## **Save Honey Hill comments on submissions made at Deadline 4**

## CWWTPR DCO Examination

## Submission by Save Honey Hill Group

Fig 1. Proposed Development, Green Belt, Conservation Areas & Listed Buildings – Fen Ditton & Horningsea

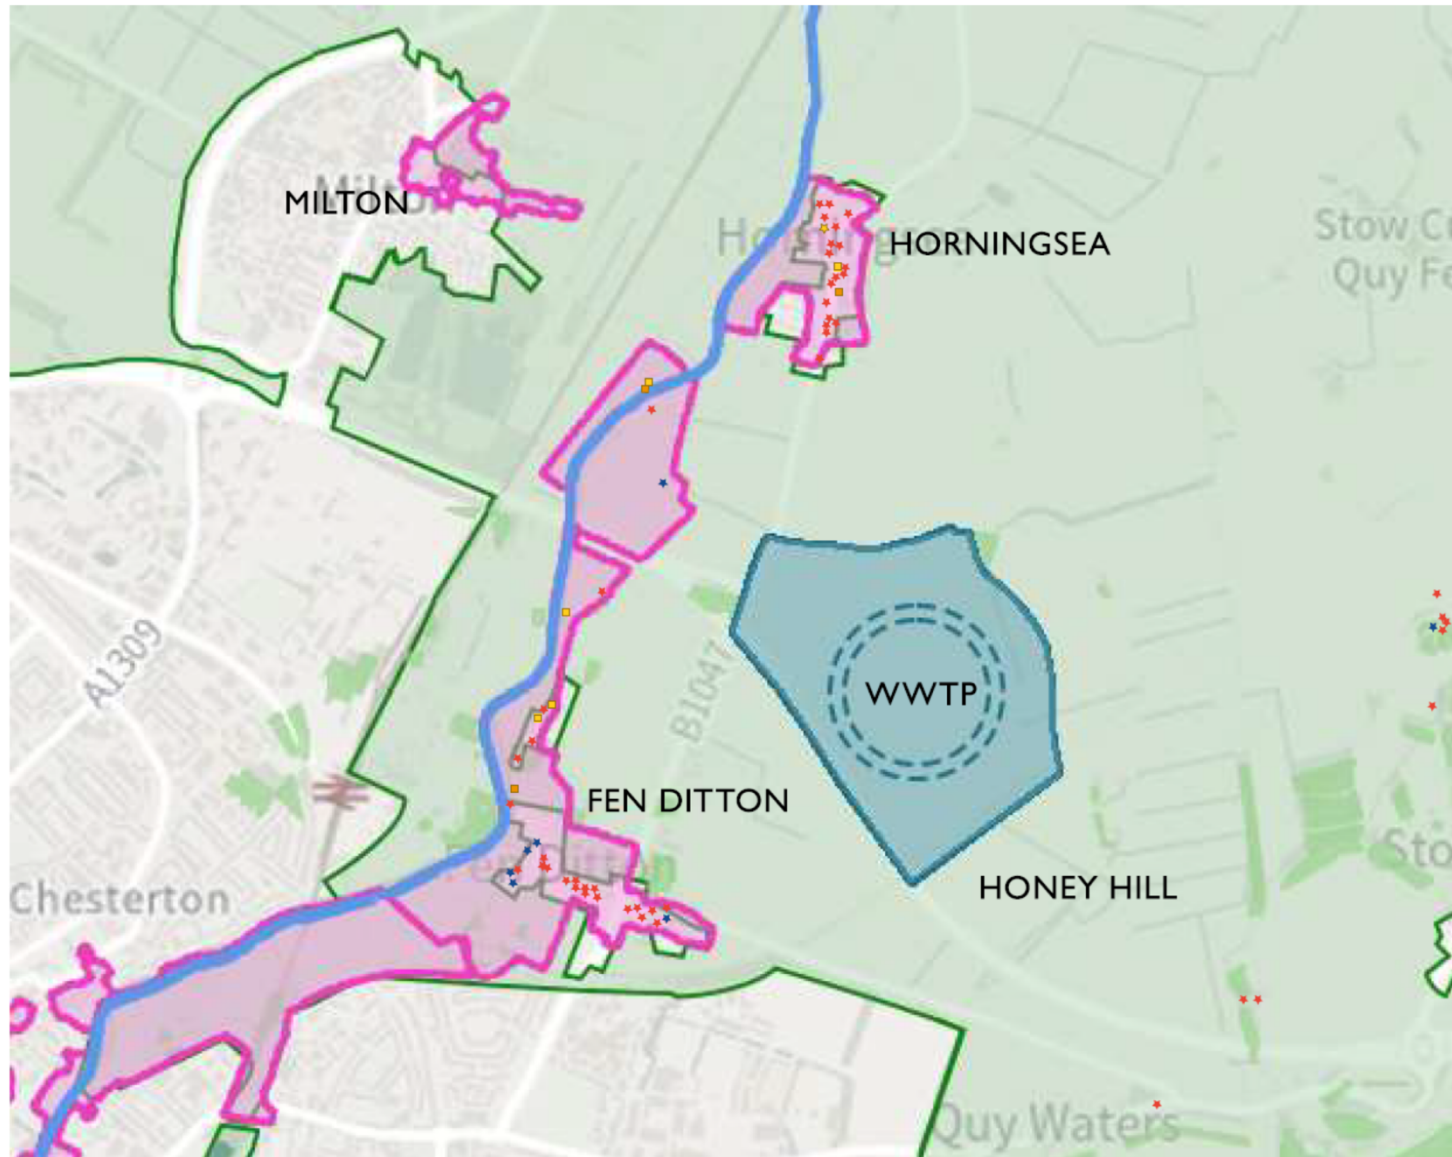
- 4.7 It is evident that harm to the Conservation Areas will, by default, also harm all the historical buildings within the CAs; in this case as a result of adverse harm to the historic agricultural setting (identified by the Applicant as HCLA22 assigned permanent construction moderate adverse residual effect at para 4.4.57 REP4-030) and the introduction of an industrial plant into the rural setting of the Villages visible when travelling along Horningsea Road and High Ditch Road.

- 5.4 In addition, the scale of the industrial infrastructure and permanent change in landscape will have a permanent adverse impact on the spatial relationship and cultural heritage of the three villages and designated assets within them all of which contribute to a shared sense of place. This adverse impact has not been captured in the Applicants assessment. It is the view of SHH that this adverse effect should be factored into cumulative effect.

- 5.5 The cumulative time scales are also significant. The construction period is identified as 4 years, a further 15 years of large scale exposed industrial plant before 'optimal maturation' of

landscape planting and beyond to permanent residual adverse effects (2.4.2,2.4.5,2.4.8 REP4-030).

- 5.6 It is SHH's understanding that the Applicant's assessment methodology does not provide for assessment or measure of cumulative impact on the historical environment.
- 5.7 SHH has not identified a figure or illustration amongst the Applicant's submissions that adequately demonstrates the scale of the proposed WWTP and landscape proposals in relation to the two Villages, Conservation Areas and designated historical assets within them.
- 5.8 Fig 1. below has been produced by SHH using official sources to provide an illustration and appreciation of the cumulative impact and effect on the historic environment. The relevant historical routes, High Ditch Road and Horningsea Road are depicted as pale white lines. The impact on the spatial relationship between the three villages and Stow cum Quy Fen can also be seen with Stow cum Quy village and Fen both partially captured to the east.
